PROJECT COMMENTS

PROJECT NUMBER: SP2026-027
PROJECT NAME: Site Plan for Texas Social Driving Range & Parking PH 1
SITE ADDRESS/LOCATIONS: 1091 Rayburn Way, Rockwall, TX, 75032

DEPARTMENT	REVIEWER	DATE OF REVIEW	STATUS OF PROJECT
PLANNING	Henry Lee	07/22/2026	Needs Review

DEPARTMENT	REVIEWER	DATE OF REVIEW	STATUS OF PROJECT
ENGINEERING	Madelyn Kuhn	07/21/2026	Approved w/ Comments

LEFT (WEST) ELEVATION

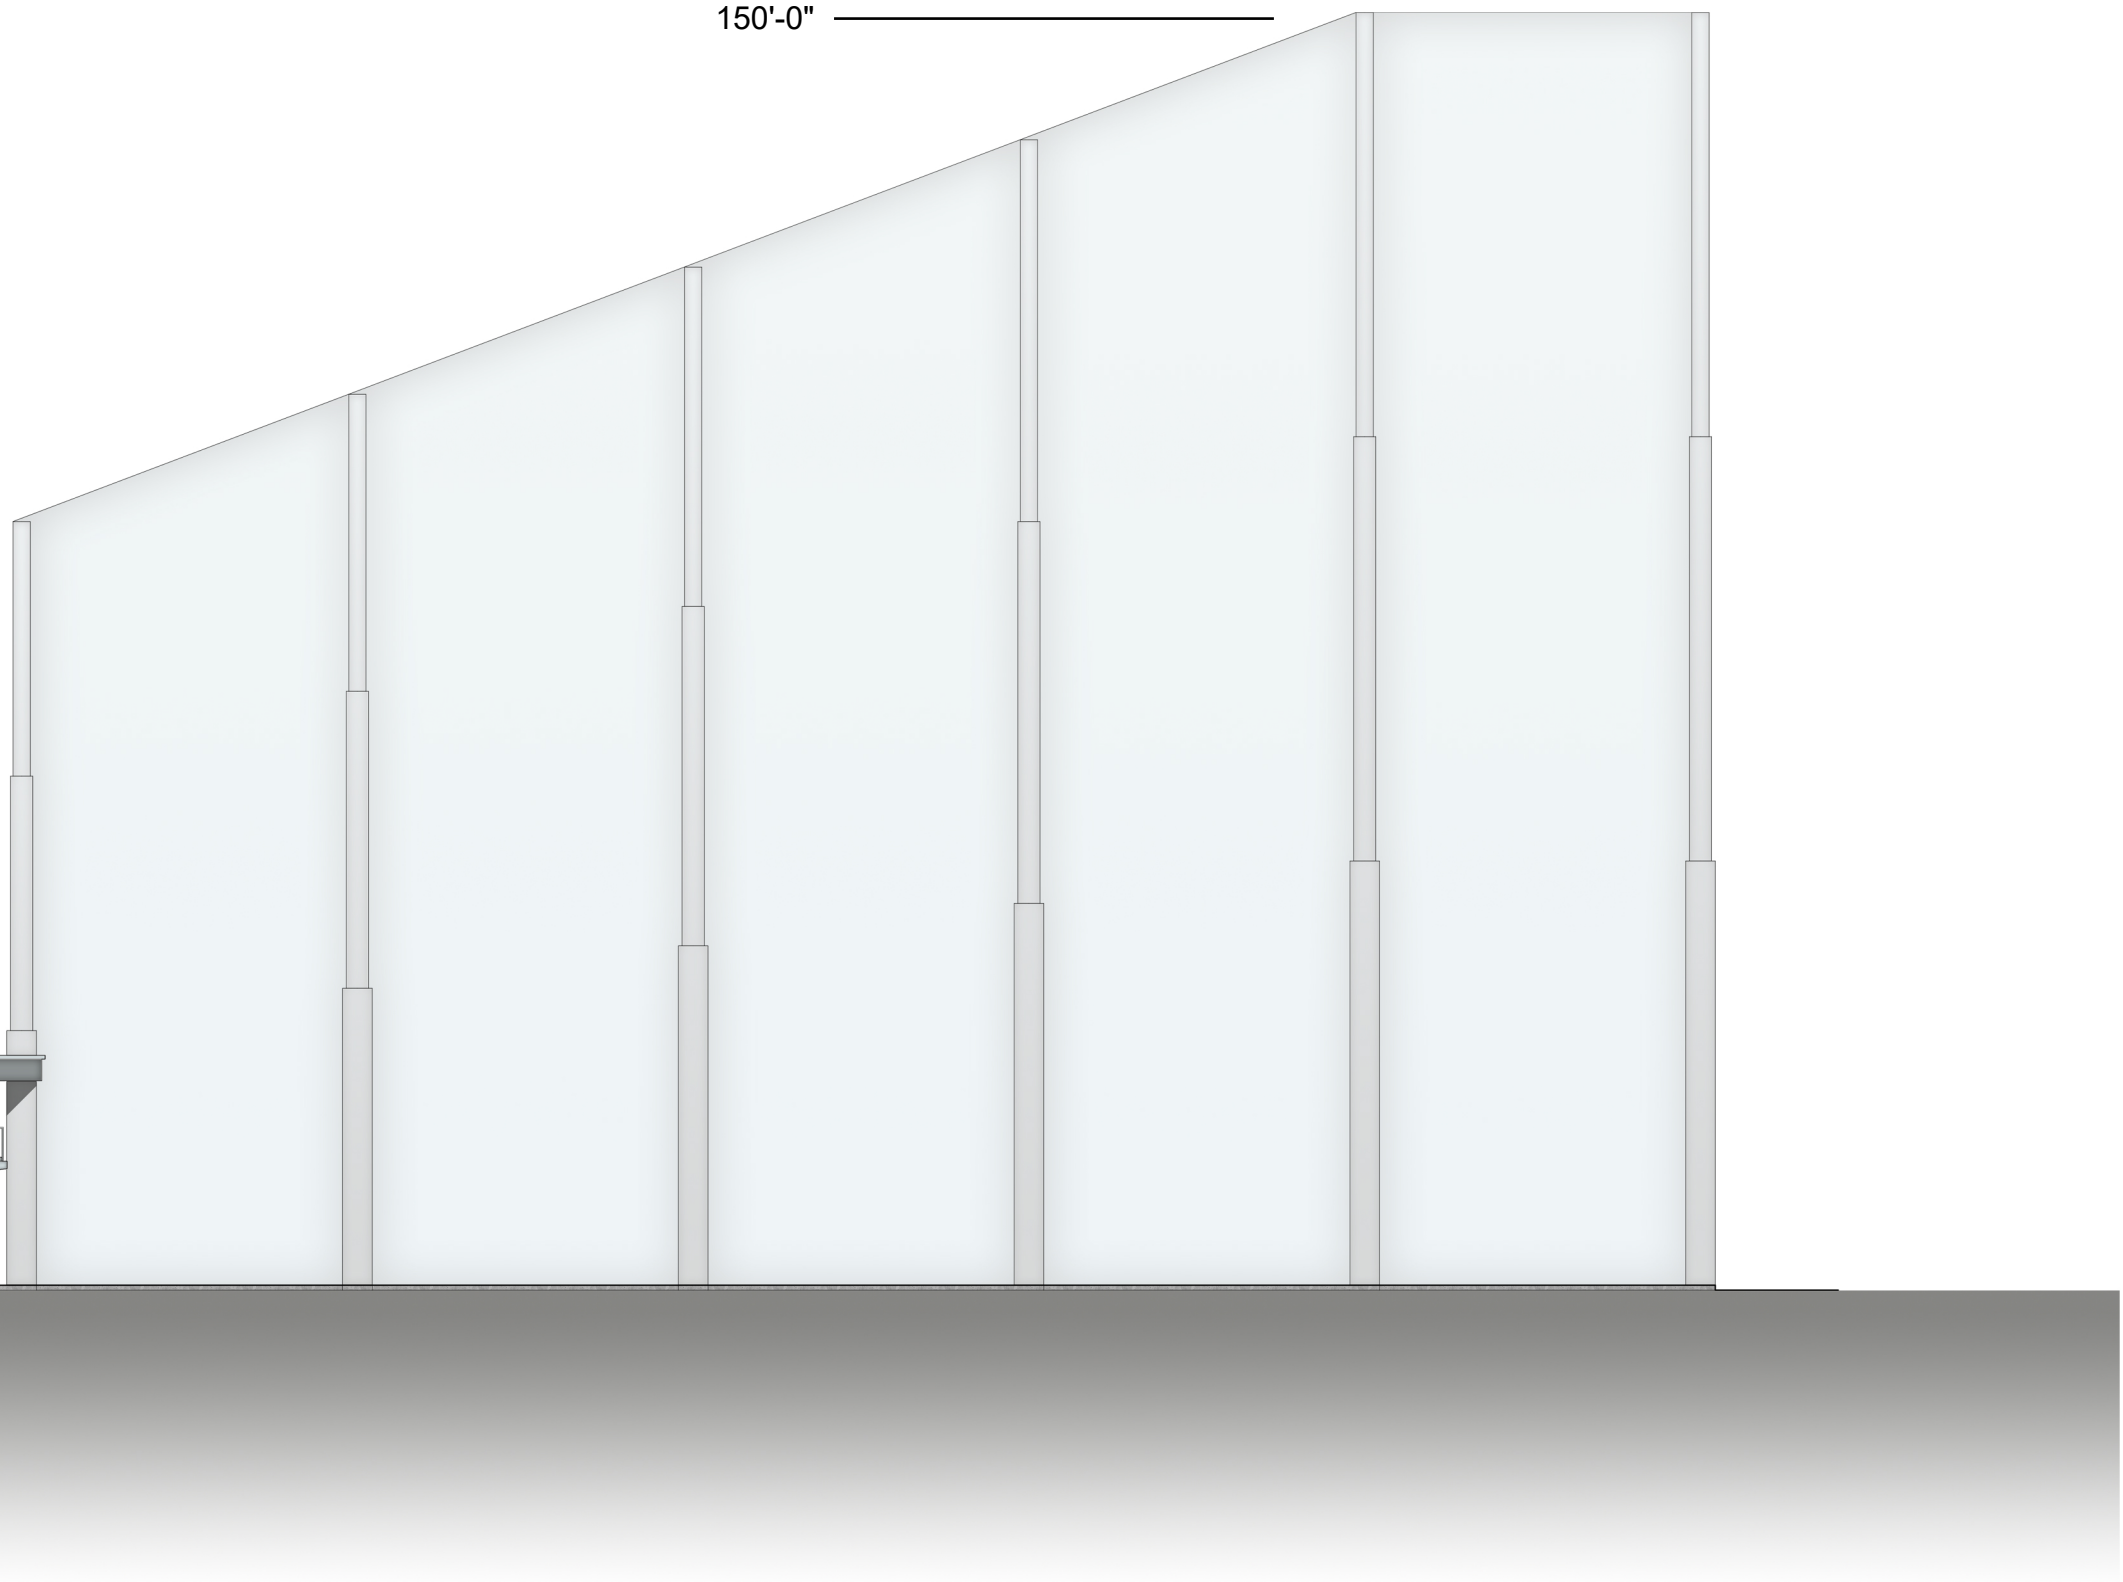
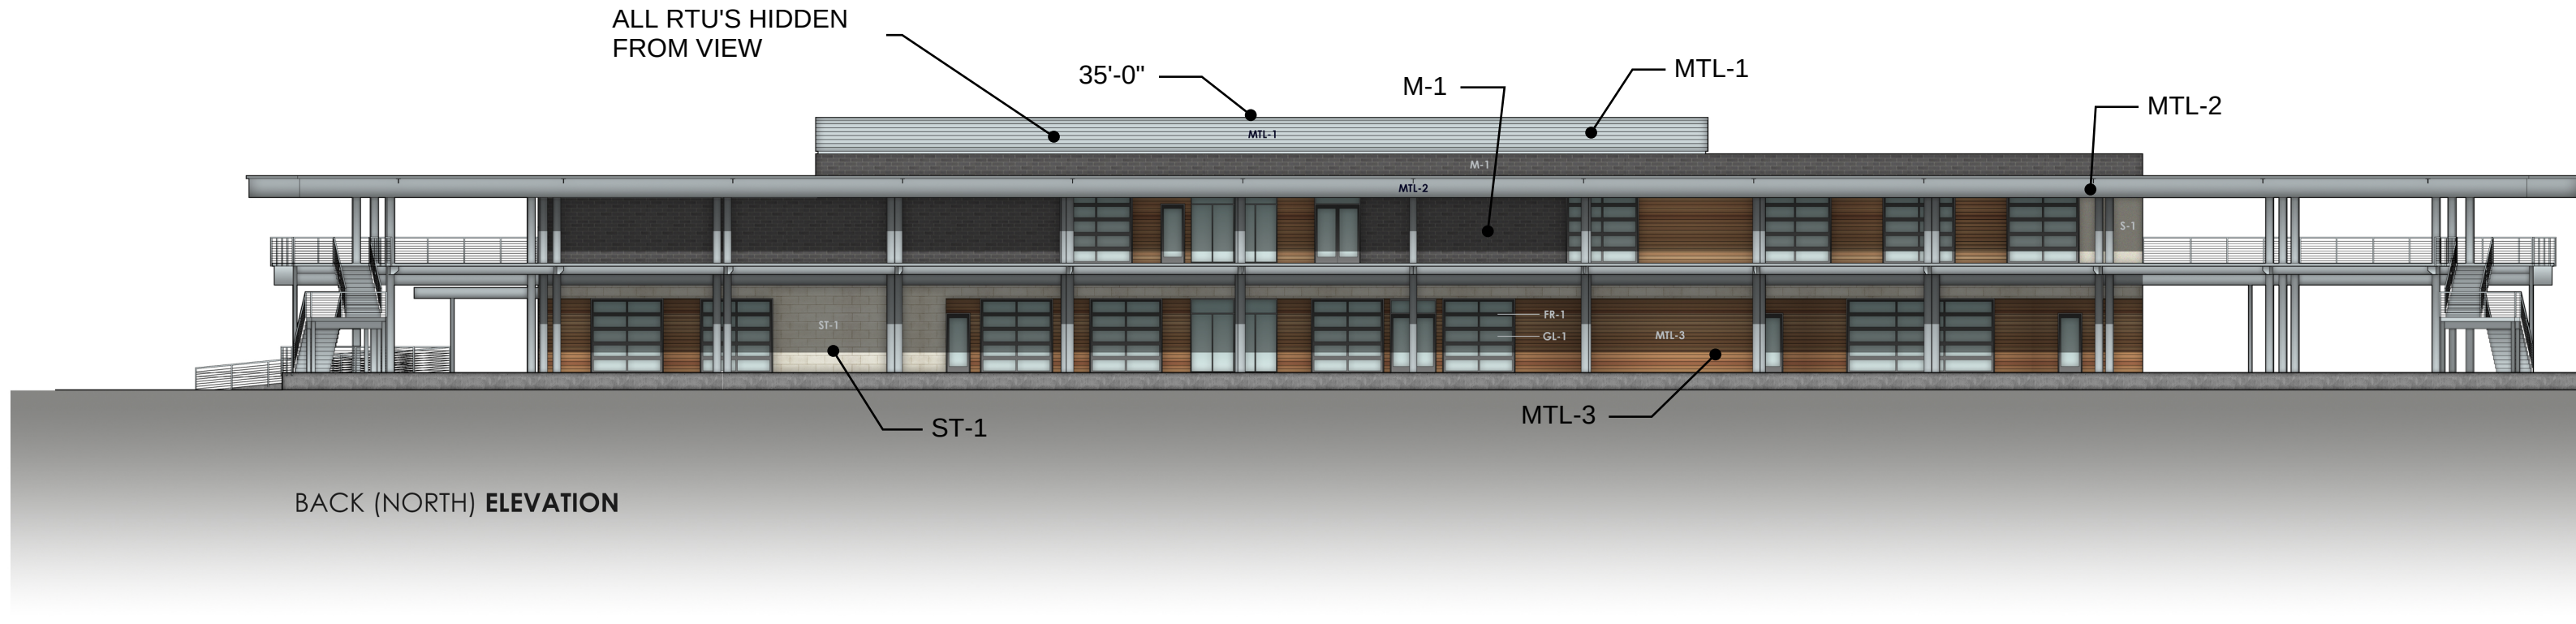
- (1) Please provide the building elevation for the maintenance building. (Subsection 03.04. B, of Article 11, UDC)
- (2) Please provide supplementary elevations of the primary building that does not have the netting included. (Subsection 03.04. B, of Article 11, UDC)

- (3) The main building incorporates greater than 10% secondary materials (i.e. metal). This will require a variance from the Planning and Zoning Commission. (Subsection 06.02. C, of Article 05, UDC)

- (4) All sides of the proposed buildings are required a minimum of 20% natural or quarried stone. Currently the backside of the primary building has less than 20% stone. Also, please clarify if the proposed stone is natural or quarried. If the stone is cast, this will require a variance from the Planning and Zoning Commission. (Subsection 06.02. C, of Article 05, UDC)

- (5) Please dash in the roof line on the building elevations. In addition, please crosshatch the RTUs. (Subsection 04.01, of Article 05, UDC)
- (6) Please indicate the architectural elements on the buildings. All buildings located within an overlay district are required to provide a minimum of four (4) architectural elements. (Subsection 06.02. C, of Article 05, UDC)

- (7) Currently the proposed building elevations do not meet the articulation requirements detailed in the General Overlay District Standards and in the General Commercial District Standards of the UDC. As indicated in the variance letter this will require a variance from the Planning and Zoning Commission. (Subsection 04.01. C, of Article 05, UDC)

TEXAS SOCIAL DRIVING
RANGE & PARKING-PHASE-1
S.H. 205
ROCKWALL, TX 75032
LANDSCAPE PLAN

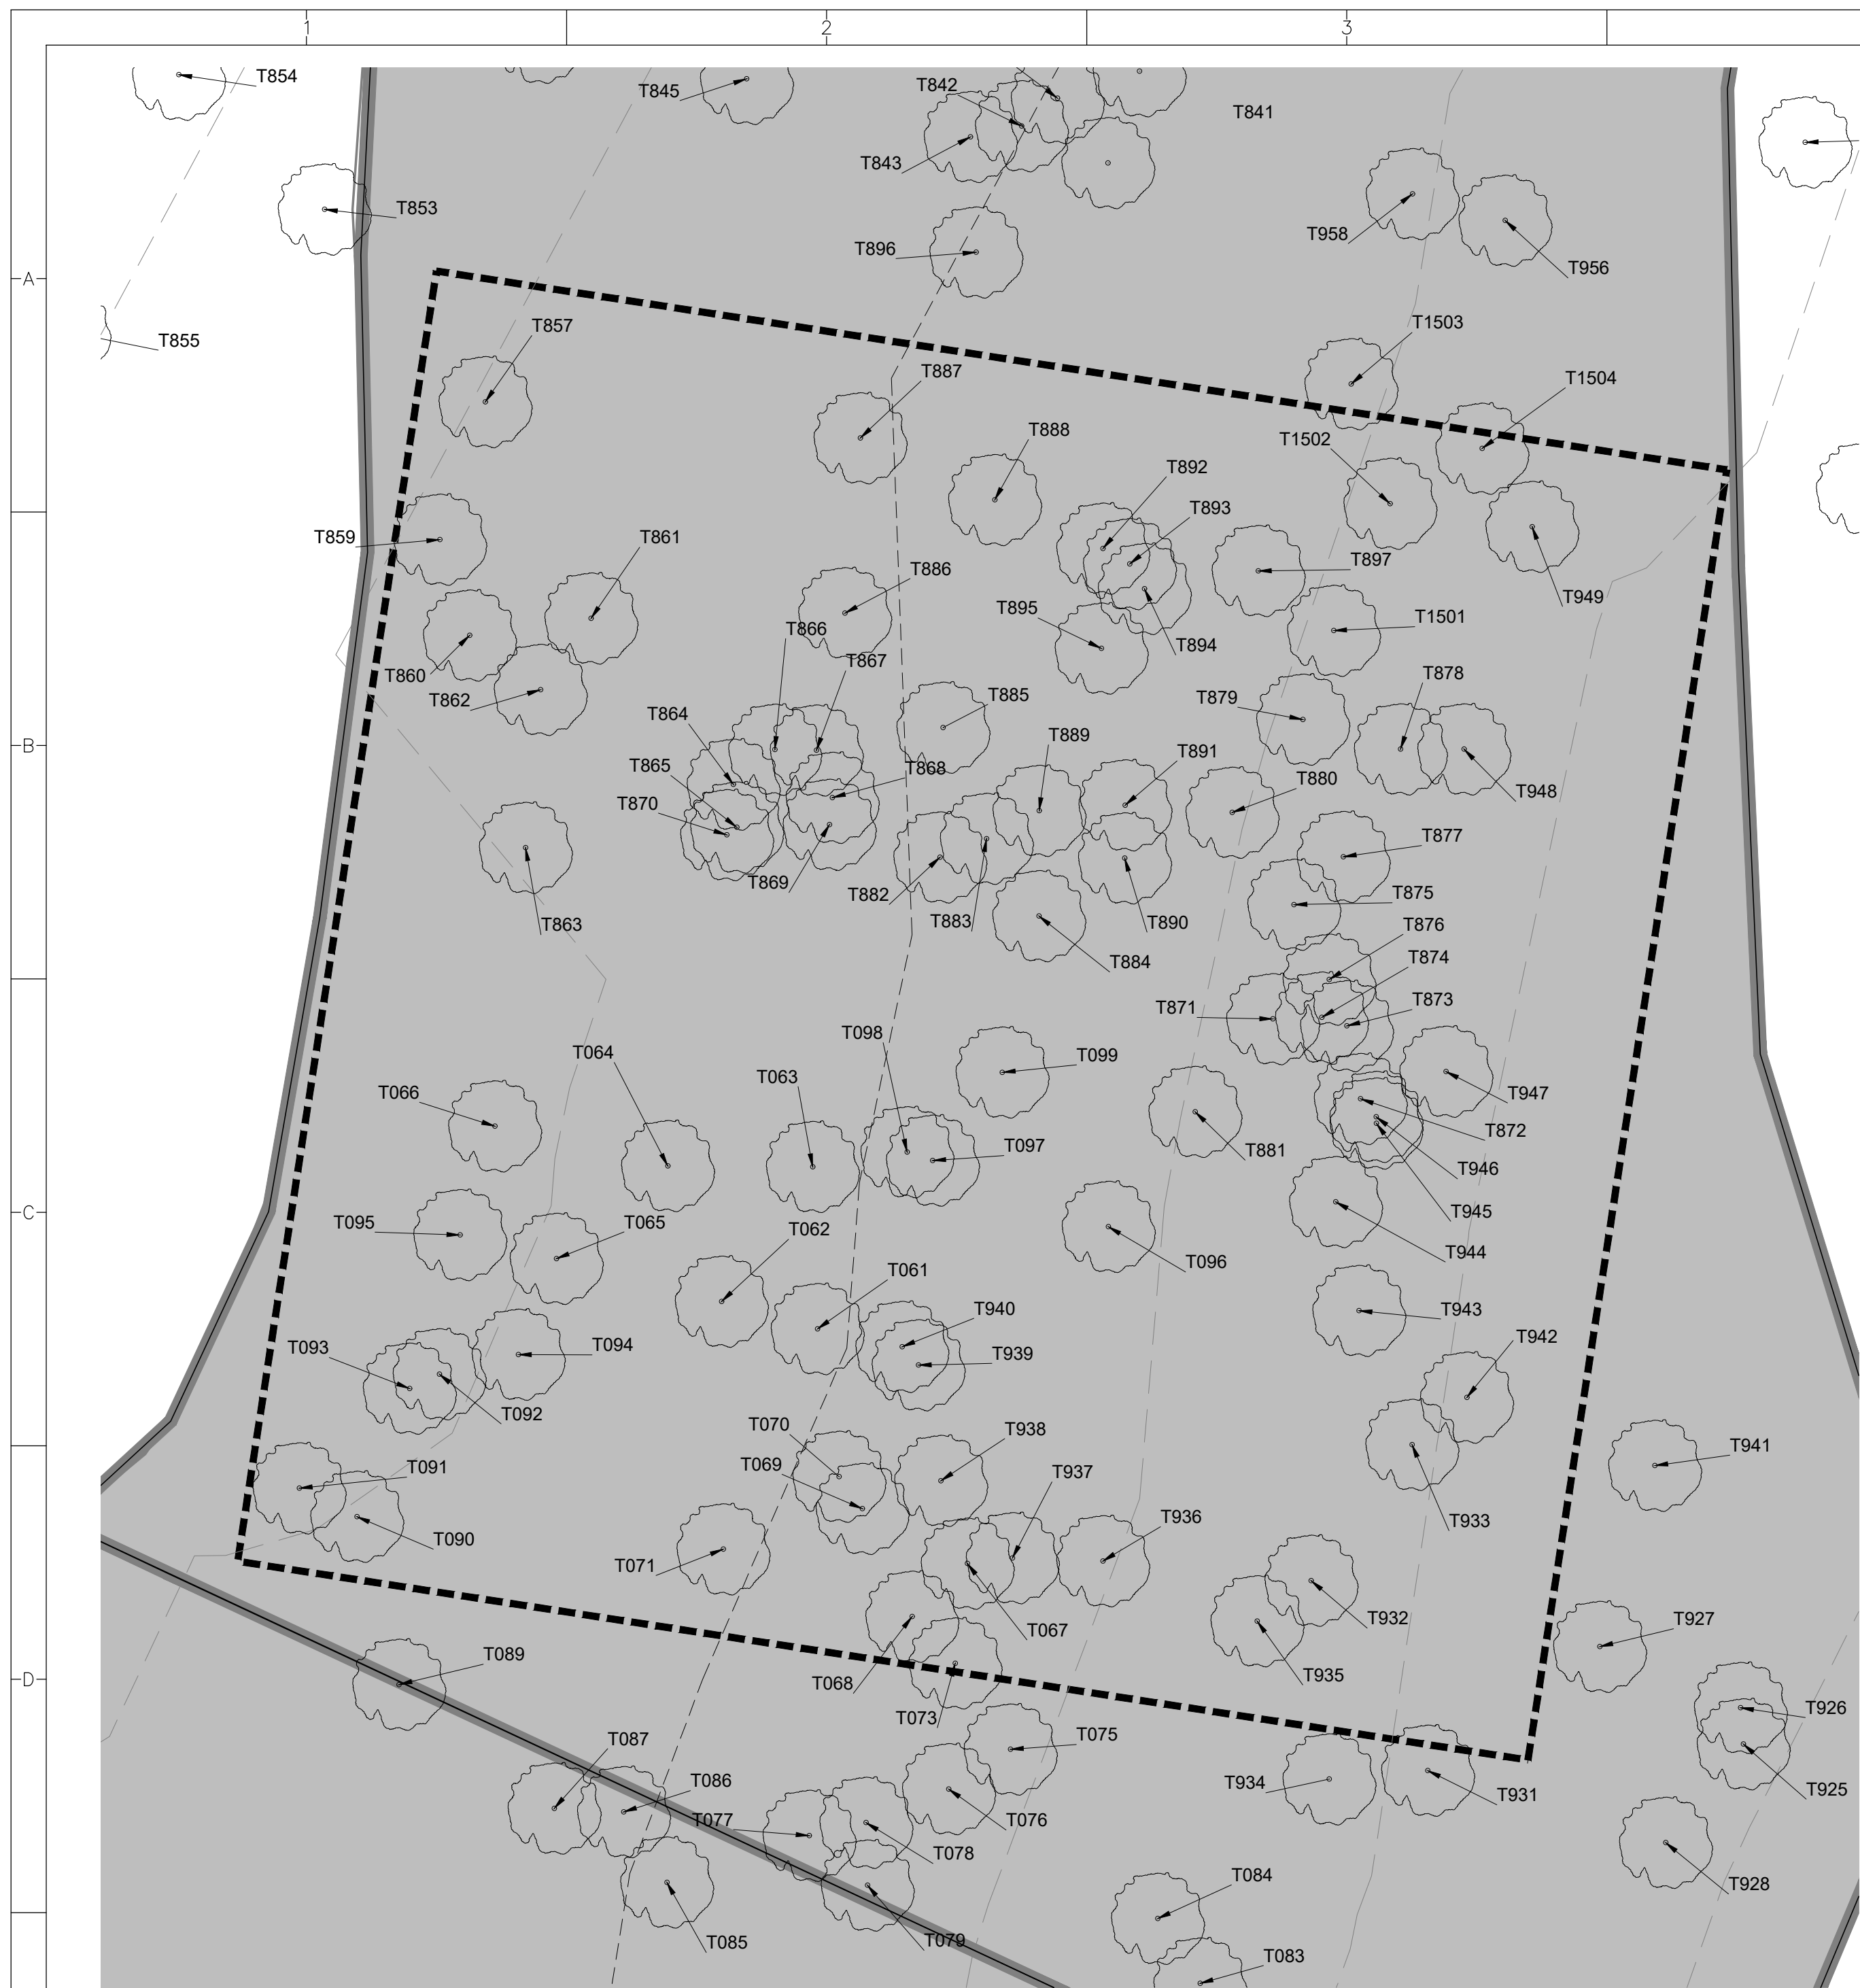
- (1) Please remove the improvements and buildings associated with Phase 2. This area can be labeled as Phase 2, but we cannot have any improvement shown in this area. (Subsection 03.04. B, of Article 11, UDC)

- (2) Provide the same site data information required in Section 2.1 Site Plan: Miscellaneous and Density and Dimensional Requirements of this checklist. (Subsection 03.04. B, of Article 11, UDC)

- (3) Please provide the impervious vs. landscaped area. Indicate the applicable zoning district percentage of landscaping required and provided, and the impervious area vs. the amount of landscaping and open spaces required and provided. (Subsection 01.01. B, of Article 08, UDC)

- (4) Please provide a landscape table showing plant materials, quantities, size and spacing for existing and proposed landscaping. Complete description of plant materials shown on the plan, including names, locations, container or caliper sizes at installation. Canopy trees must be four (4) inch caliper, accent trees must be four (4) feet in height, and all shrubs must be five (5) gallons. (Subsection 05.03. B, of Article 08, UDC)

- (5) Please delineate and label the landscape buffer along S. Goliad Street and Sids Road. In this case, the landscape buffer along S. Goliad Street is 20-feet and the landscape buffer along Sids Road is 10-feet. Within the landscape buffer along S. Goliad Street, there must be 19 canopy trees, 37 accent trees, a row of shrubs, and a 30-inch berm. Within the landscape buffer along Sids Road, there must be 13 canopy trees, 13 accent trees, a row of shrubs, and a berm. (Subsection 05.01, of Article 08, UDC)

- (6) Detention basins shall be landscaped in a natural manner using ground cover, grasses, shrubs, berms, and accent and canopy trees. There shall be a minimum of one (1) canopy tree per 750 SF and one (1) accent tree per 1,500 SF of detention area. (Subsection 05.03. (D), of Article 08, UDC)

- (7) Given that the parking and maneuvering area exceeds 20,000 SF there must be one (1) large canopy tree for every ten (10) parking spaces planted internal to the parking areas. (Subsection 05.03. (E)(2), of Article 08, UDC)

- (8) Please provide note indicating irrigation will meet requirements of UDC. (Subsection 05.04, of Article 08, UDC)
- (9) Artificial or synthetic plant materials (e.g. artificial grass, turf, trees, and/or shrubs) shall be prohibited on all non-residentially zoned or used property in the City of Rockwall; however, the Planning and Zoning Commission can grant an exception where it is found that the artificial plant materials are integral to the operations of the proposed non-residential land use or where it will serve as an on-site amenity to the nonresidential land use. Please detail where any artificial turf will be utilized and its purpose. (Section 04. (B), of Article 08, UDC)

07/20/2026: Please provide a required versus proposed landscape legend
This should include plant varieties with common and latin names, size, etc
